TECHNICAL EVALUATION REPORT  
VERMONT YANKEE NUCLEAR POWER STATION  
STATION BLACKOUT EVALUATION

TAC No. 68620

Final  
November 26, 1990

U.S. Nuclear Regulatory Commission  
Washington, D.C. 20555

FIGURE 1. VERMONT YANKEE AC POWER SYSTEM

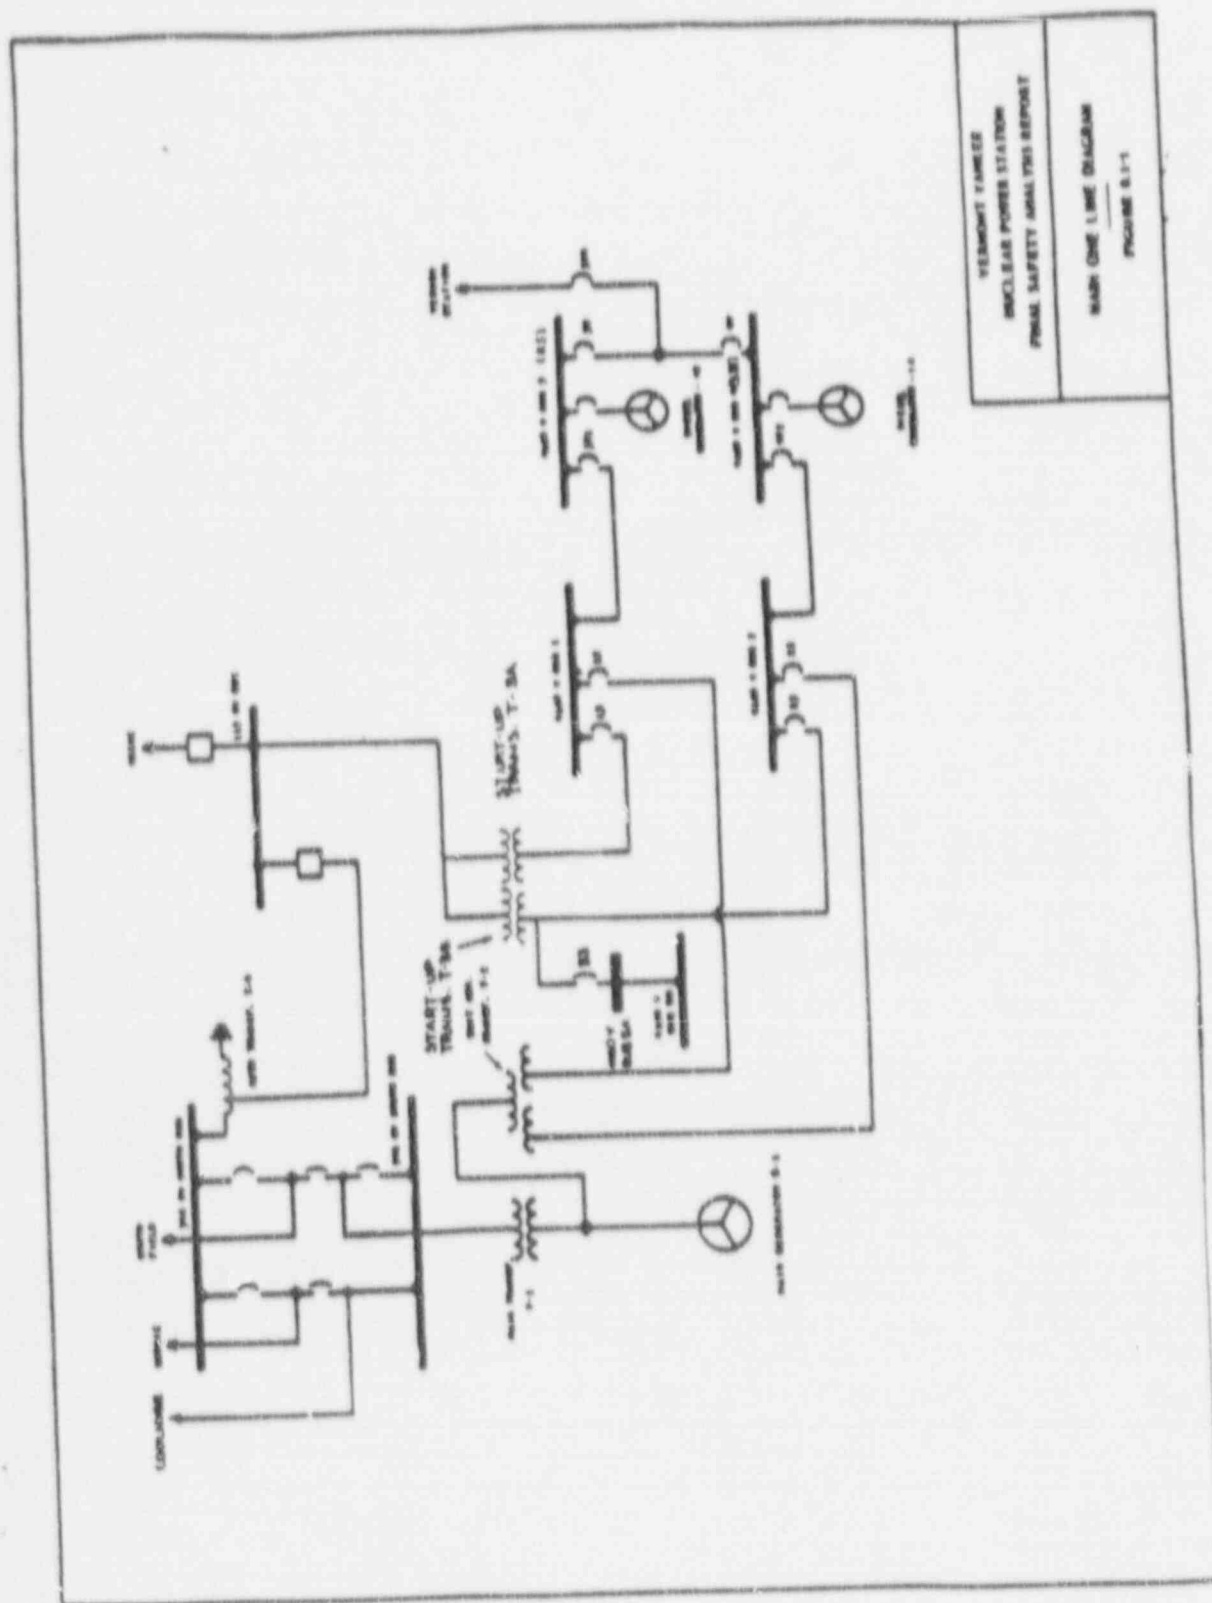
The licensee bases the independence of offsite power system grouping of "1 1/2" on the following (see Figure 1):

1. all offsite power sources are connected to the plant through two electrically connected switchyards,
2. there are two emergency safety feature divisions, and each division is normally powered from the main generator via a winding of the unit auxiliary transformer T-2,
3. upon failure of the main generator, the safe shutdown buses are automatically transferred to start-up transformers T-3A and T-3B which are powered from a 115 kV bus, (the 115 kV bus is normally powered from the 345 kV switchyard), and,
4. upon loss of 345 kV power to the 115 kV bus, the bus can be manually transferred to the 115 kV power line from Keene. The safe shutdown buses are still receiving power from the start-up transformers T-3A and T-3B.

For a plant with electrically connected switchyards, NUMARC 87-00 states that a plant should be considered to be group "I3" if *"The normal source of AC power is from the main generator and there is one automatic transfer and no manual transfers of all safe shutdown buses to one preferred or one alternate off-site power source."* The automatic transfer to the start-up transformers (item 3. above) is acceptable, but the manual transfer (item 4.) involves using the same power source (the start-up transformers) as is used for the automatic transfer. Item 4. is not a valid transfer because a failure of either the 115 kV bus or the start-up transformers would preclude the ability to power the safety buses. Therefore, we conclude that Vermont Yankee is in offsite power group "I3."

FIGURE 2. VERMONT YANKEE ALTERNATE AC POWER SOURCE

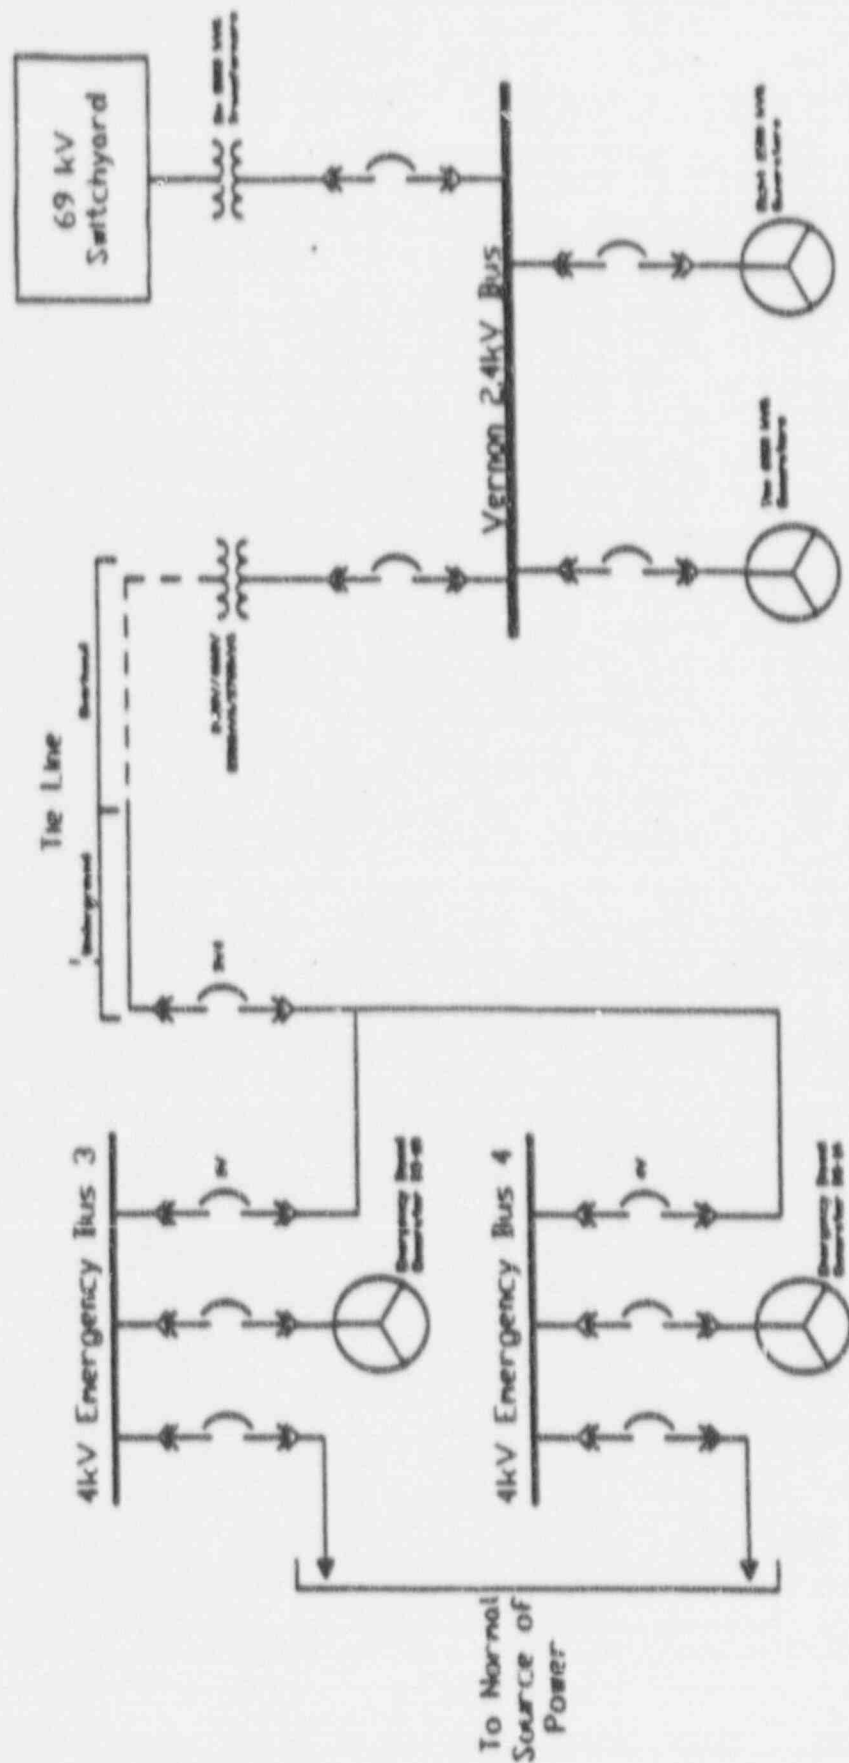
The licensee stated (10) that an existing 4,160 V tie line to the New England Power Company's (NEPCO's) Vernon Hydroelectric Station will be used as the alternate AC (AAC) power supply, see Figure 2. The Vernon Station has ten 6,000 kVA hydro-electric generators and is connected to the grid via four 69 kV lines. The Vermont Yankee plant is connected to Vernon by a 4,160 V fully insulated cable which runs on a pole line for about 2,300 feet and then runs underground for approximately 1,700 feet to the Vermont Yankee switchgear. The licensee stated that the normal operational mode of Vernon requires that at least 6,000 kW of generation capacity always be connected to the grid either as spinning reserve or as running capacity. The maximum capacity of the transformer that feeds Vermont Yankee is 3,300 kVA, which can be delivered to either of the safety buses as shown in Figure 2. The licensee stated that the control switches for the three breakers (3V, 4V and 3V4) needed to energize the safety buses (Bus 3 and Bus 4) are located in the Vermont Yankee control room and that the availability of the Vernon tie-line is indicated continuously in the control room.

The Vernon Hydroelectric Station has adequate capacity even if only one hydroelectric generator is available. However, the AAC capacity is limited by the capacity of the 2.4 to 4.16 kV transformer which is located in the line coming from Vernon hydroelectric station. The maximum capacity of this transformer is 3,300 kVA based on the continuous operation its cooling fans as given in Section 8.5.5 of the plant UFSAR. The licensee erroneously showed a 2,700 kVA capacity in its submittal (10), and confirmed that the UFSAR rating is correct during the telephone conversation on May 16, 1990. Using a power factor of 0.8, this corresponds to an AAC system load capacity of 2,640 kW. Referring to the EDG loads listed in Figures 8.5-1 and 8.5-2 of the UFSAR, the total electrical load for an EDG following a design basis accident is 2,308.4 and following a LOOP is 2,287.9 kW. Therefore, assuming that transformer cooling fans are operating, the AAC system has adequate capacity and can be considered to be approximately equivalent to one EDG since either the EDG (with continuous capacity of 2,740 kW) or the AAC system is capable of powering the design basis accident loads. We cannot verify the power supply for the transformer cooling fans from available drawings and documents, but since we have no evidence to the contrary, we accept the licensee's statement that the fans will be operational during an SBO event.

Except for the following concerns, we agree with the licensee's statement that the AAC power source (the Vernon Hydroelectric Station) meets the criteria in Appendix B of NUMARC 87-00:

1. The proposed AAC source is owned, operated and controlled by another company. Therefore, the NRC needs to determine whether it qualifies as an acceptable AAC source for the licensee.

2. The proposed AAC source is offsite and some 4000 feet away. Therefore, the NRC needs to determine whether the proposed AAC source meets the "nearby" requirement of RG 1.155, Section 3.2.5.

3. The licensee needs to protect the AAC equipment from weather-related events that may initiate the loss of off-site power event. Our concern is that the overhead AAC cabling is not protected from weather in accordance with Criterion B.3. Since the major contributor to the total LOOP frequency of the site is snow (Using the formulae in NUMARC 87-00, snow-caused LOOP frequency is  $1.0E-2$ /yr. compared to a total ESW and SW caused LOOP frequency of  $1.5E-2$ /yr.) and snow effects all cable rights-of-ways equally, it is very important to protect against a major snow storm that could cause loss of preferred off-site power and loss of the AAC system.
